Service Campaign Notification

Campaign #	Description	Replace the Transmission Control Unit
2026060005	26P2790503

CAMPAIGN NO.	2026060005
CAMPAIGN DESC.	26P2790503
SUBJECT	Replace Transmission Control Unit
MODEL(S)	S-class (223.179/979 with engine 279 and transmission 725.0)
MODEL YEAR(S)	2026
CAMPAIGN POPULATION	68

Illustration 1

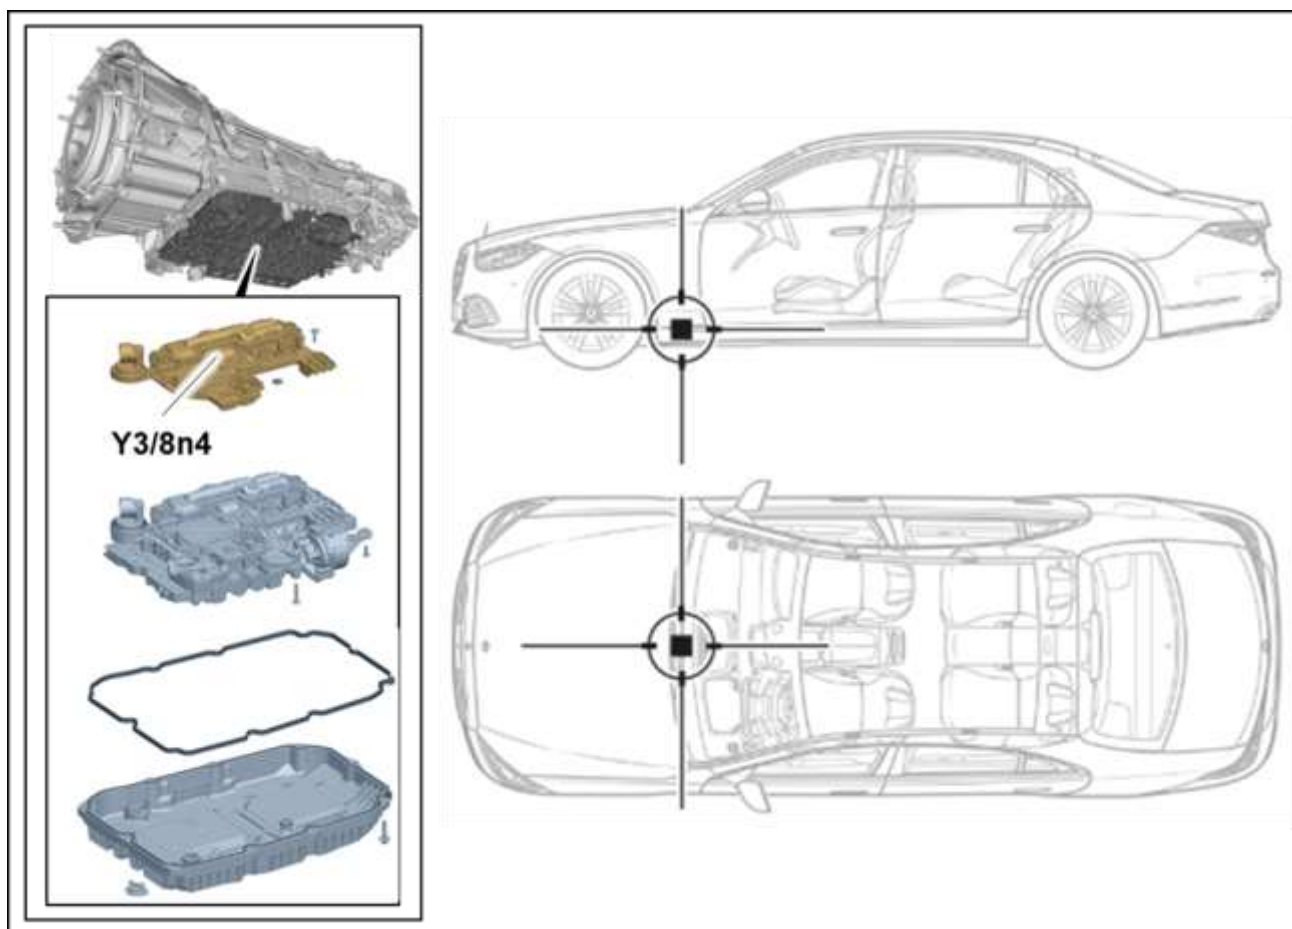
It is very important to follow the user guidance in XENTRY Diagnosis using the blue hyperlink provided by IPR. Ensure the same XENTRY unit is used when performing initial start-up of new control unit. See **Illustration 1**
